**RPSC – Technical Matters Raised at RPSC Committee Meeting, 19th March 2015 and
Subsequent WWTP Visit and LTS Visit
Issue Date 2 April 2015**

The following questions were raised at the Committee Meeting and the subsequent visits on 19th March 2015. In order to advance these the following question and answer sheet has been prepared by Jim Bradley (TAG Chair and RPSC Facilitator) and Greg Manzano (RDC Project Manager).

Figure 1.0 Relative Particle Sizes (Koch, 2004)

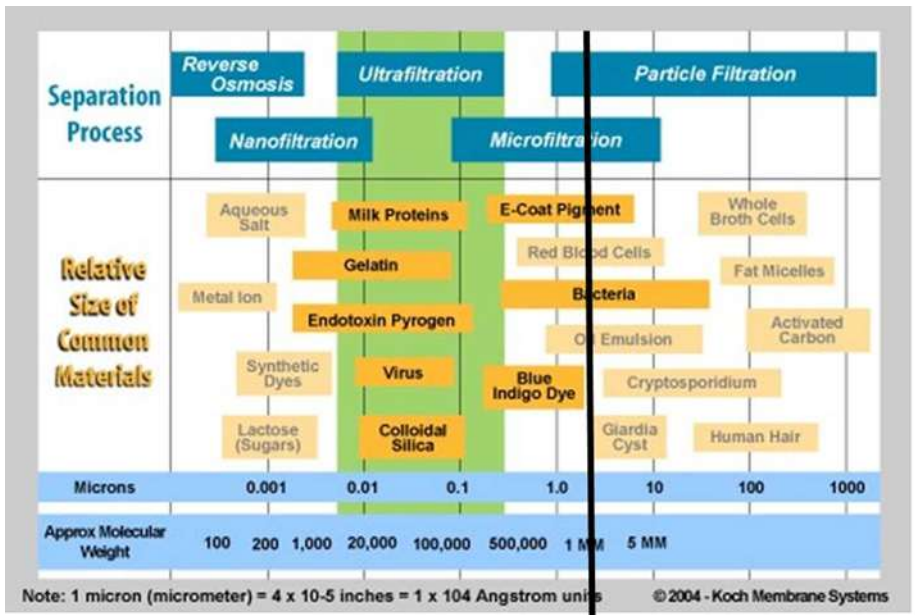
Marked up particle size graph given out at RSPC 19th March showing the Rotorua WWTP MBR with the 4 micron pore (membrane hole) size.

Please note – micron scale is a log scale

Rotorua WWTPP – MBR
 4 micron pore size (approx location)

- The matter of particle and microorganism size was covered in relation to the discussion on reverse osmosis at the RPSC 19th March. Slide 15 shows the relative sizes of a reverse osmosis membrane pore to a herbicide and pesticide molecule smallest virus, smallest bacteria and giardia cyst.
- During the Rotorua WWTP visit on 19th March, Plant Manager Andy Bainbridge, confirmed that the MBR pore size is 4 microns. This 4 micron pore size has been marked up on Figure 1 Relative Particle Sizes (Koch 2004). This figure elaborates on the relative size presentation in Slide 15 referred to above. It needs to be appreciated however, that the micron scale on this figure is a log scale.

"micro-organism removal from wastewater treatment protozoa (giardia and cryptosporidium) are 10-20 microns, viruses - enterovirus is 0.025-0.085 microns and calicivirus is 0.027-0.040 microns. Common Norovirus is 0.020 microns or 20 nanometres and Rotovirus is 0.060 microns or 60 nanometres. Therefore ultra- filtration at 0.01 microns is effective against all viruses"
